FMS Technical Bulletin

Bulletin #FMS003

2026 RH Lidar Holster Mount Update

Date: 8/28/2026

Old mount - holster behind mount point.

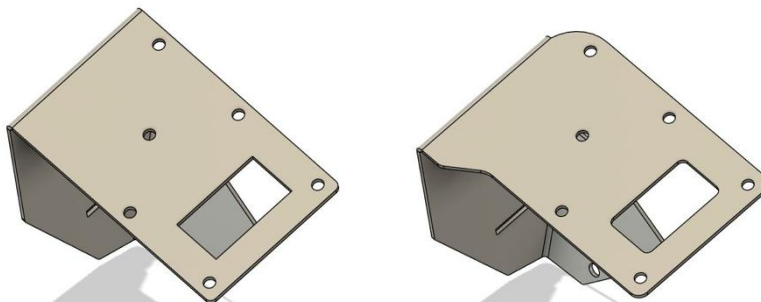
Old mounts look like the ones below.

New mount - holster ahead of mounting point

Complaint: Riders reported that the early Lidar gun holster mounts for 2026 R 1300 RT-P models may alter the path of hot air from the radiator exhaust, causing rider discomfort.

Solution: After extensive testing, a redesigned holster mount was developed for the R 1300 RT-P which moves the holster forward to eliminate disruption of radiator heat exhaust.

Field Solution: Replace early version Lidar gun holster mounts with the new mount. This will eliminate the air deflection, though heat is still exhausted from the radiator.

New RH Lidar Holster Mount

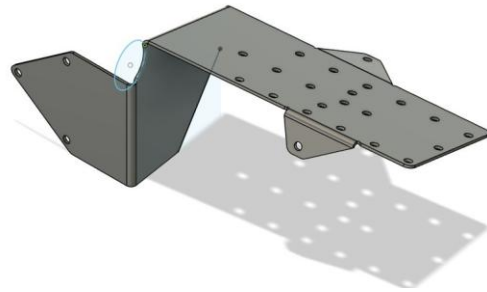
Note: Early Zebra printer mounting brackets attached to the Lidar mounting bracket. A new bracket will be needed that will work with all combinations or stand alone. That new bracket shown above is in production now with availability in early September. The new Zebra mount will be available for purchase once in stock.
